STOUGHTON LAKE DAM
(BEAVER DAM)

NDI No. PA 00468
PennDER No. 56-78

PHASE I INSPECTION REPORT
NATIONAL DAM INSPECTION PROGRAM

Stoughton Lake Dam (Beaver Dam), Somerset County, Pennsylvania
NDI No. PA 00468, PennDER No. 56-78
Beaverdam Creek
Inspected 12 December 1979

PHOTO 8. View of Outlet Structure (Note erosion around structure)

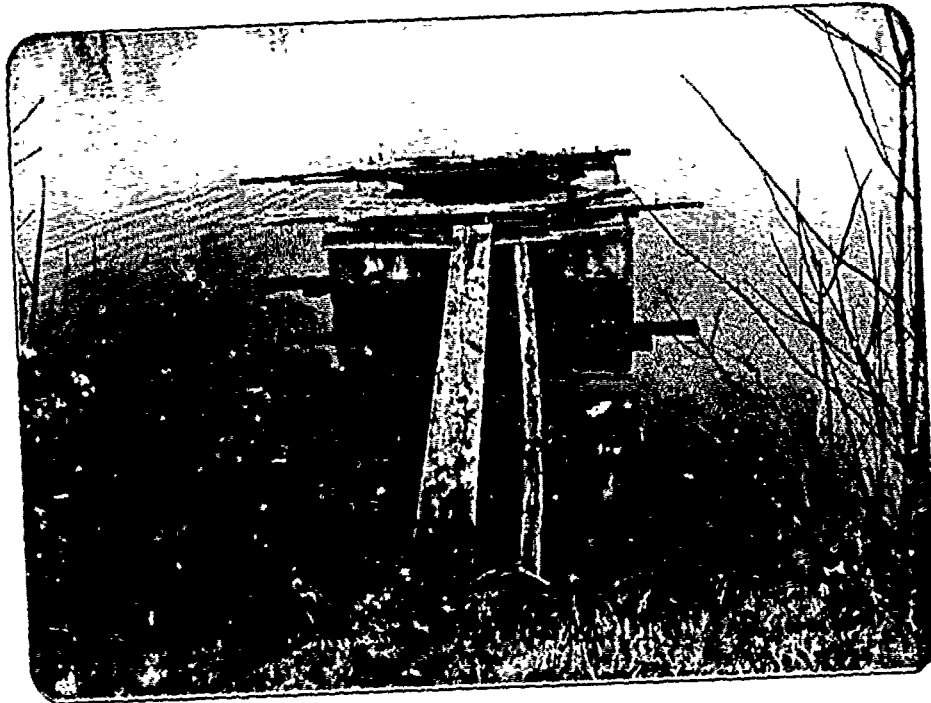
The outlet structure was partially submerged and the observable portions were in good condition. Some erosion of the embankment has occurred around the outlet head wall. This erosion, according to the owner, is the result of surges from the cutlet conduit washing onto the embankment. These surges are probably the result of air pockets trapped in the conduit which are later forced out.

- 3) The eroded areas around the outlet head wall should be repaired and the area reseeded.
- 4) Clear the trees and brush from the dam and continue in the future to maintain this item.

PLATE 3

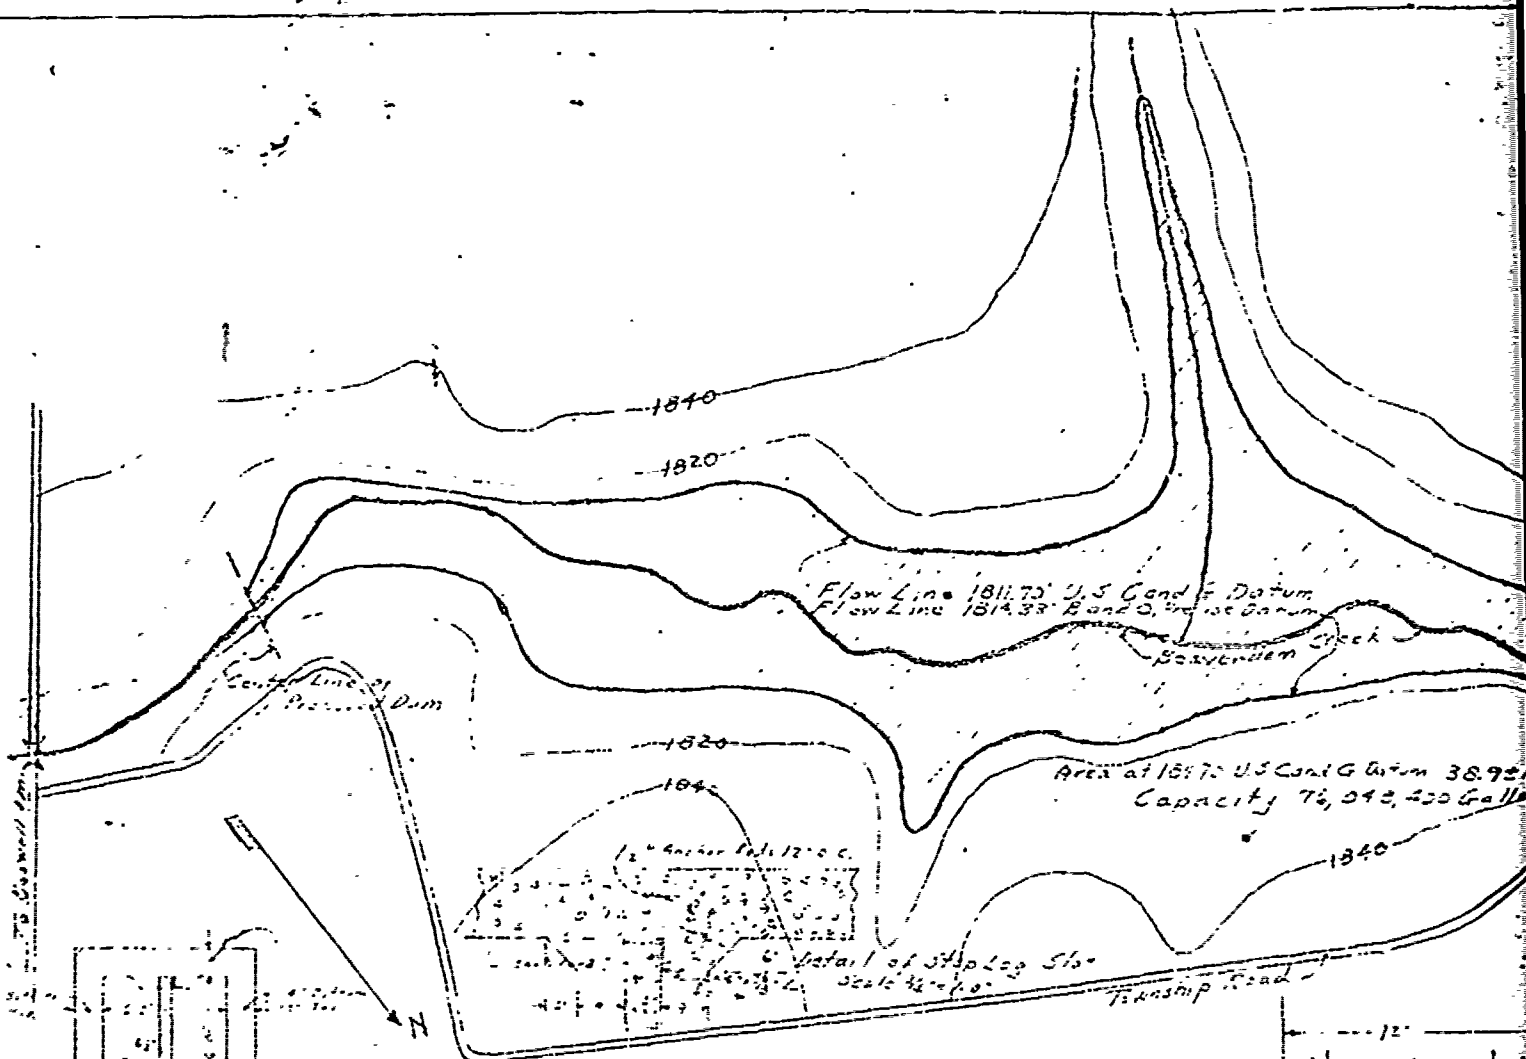
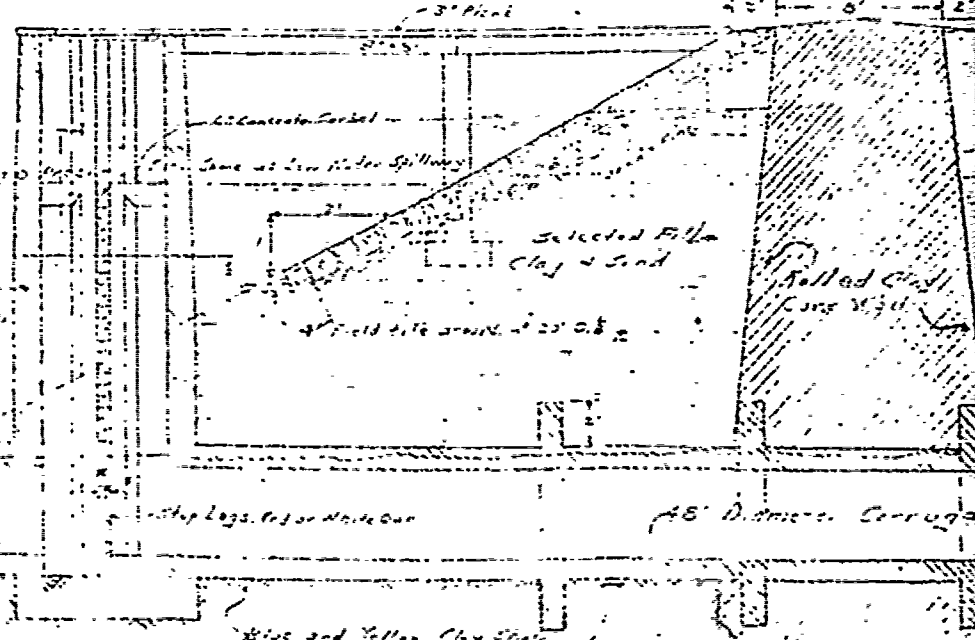
- 1) The top width is approximately 24 feet and not 12 feet.
 - 2) The downstream slope is approximately 3H:1V and not 2H:1V as indicated on the design plans. This resulted in an extension of the outlet conduit.

- 3) The intake riser unit was not constructed to Elevation 1821.3 feet but was constructed to Elevation 1816.1 feet.
 - 4) The outlet pipe conduit is 36 inches and not 48 inches as shown on the plans.

- 5) No access bridge to the intake riser was constructed.
 - 6) The spillway training wall footings are smaller than shown on the design plans.
 - 7) The actual amount of steel reinforcement in the spillway walls as compared to the design plans is questionable.
